Donald C. Cook Nuclear Plant, Unit 1  
Docket No. 50-315  
DPR No. 58

This letter, including attachments, responds to your letter of December 3, 1975 requesting additional information regarding the switchover from injection to recirculation and procedures permitting diversion of flow from the low head pumps to the containment spray system.

Attachment A

Response to NRC Questions from

FIGURE I

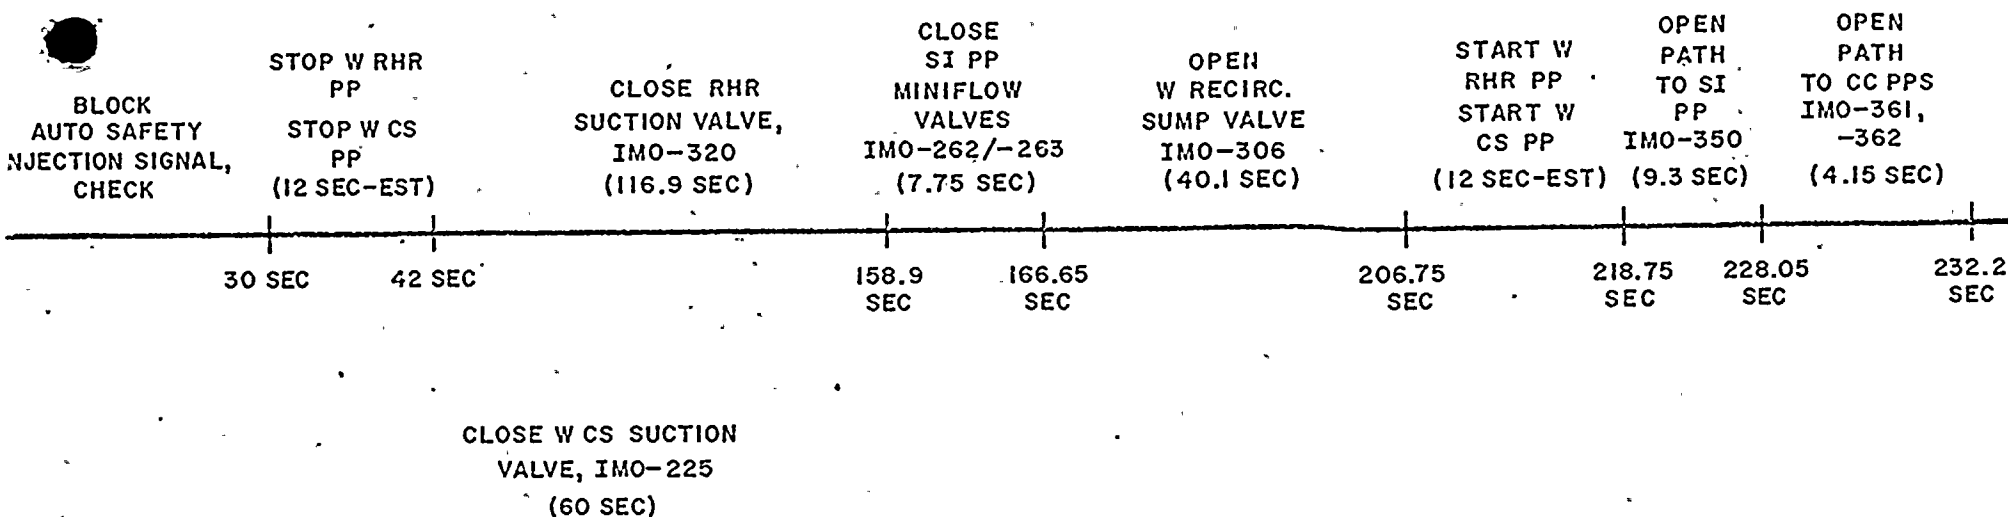
Demonstrate that adequate time is available to perform the switchover from injection to recirculation.

- a) Provide the time required to realign the valves and pumps, including personnel response time, valve actuation times, and the effects of any valve/pump interlocks.
- b) Provide a time history of the water inventory in the RWST while the switchover is being performed under the most adverse conditions relative to time available to perform the necessary switchover.
- c) If all pumps are shut down during switchover, provide the time available before the core is uncovered.

Following an accident the shortest time when the operator must take action to perform the necessary switchover is when both trains of ECCS and spray pumps are in operation at full runout conditions. This is because the RWST is emptying at the fastest possible rate, thus requiring the most rapid operator action to perform the switchover from injection to recirculation.

The limiting times required to switchover the first train of pumps are shown on Figure 1 and the associated RWST level above the low-low level alarm setpoint (613') is shown on Figure 2. Once a single train is switched over and operating, an adequate water supply is assured to both the reactor core and the containment sprays. The switchover of the second train supplies redundant capability. The switchover procedure requires stopping only the RHR pumps, the other pumps run continuously while the RHR pumps are shutdown. At no time in the switchover procedure are all pumps shutdown. Therefore, core uncover is not expected to occur.
